SUMMARY INDEX
HISTORIC DISTRICTS REVIEW BOARD
May 28, 2019

MINUTES OF THE
CITY OF SANTA FE
HISTORIC DISTRICTS REVIEW BOARD

May 28, 2019

202 GONZALES ROAD

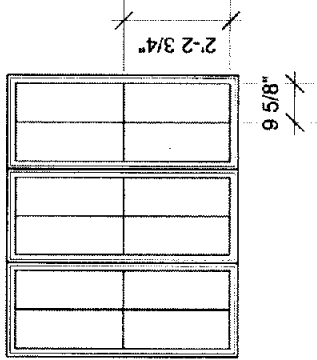
Mr. Edward Trujillo was sworn. He said he was at the site when Staff said if he did replace the windows, that the Board might want to see the pattern that he used. So he made a copy of the lite pattern to share with the Board. It is very likely that some of those windows would need to be replaced.

Chair Rios understood he would need to replace some windows and pointed out that two on the front appeared to not have divided lights.

Mr. Trujillo said those were questionable.

MOTION: **Member Lotz moved, seconded by Member Roybal, in Case #H-19-041 at 202 Gonzales Road, to approve certain items - 1, 2, 3, 4, 6, 7, and 8, approve the divided lites, and on 9, 10, and 11, to have the applicant come back with a revised application.**
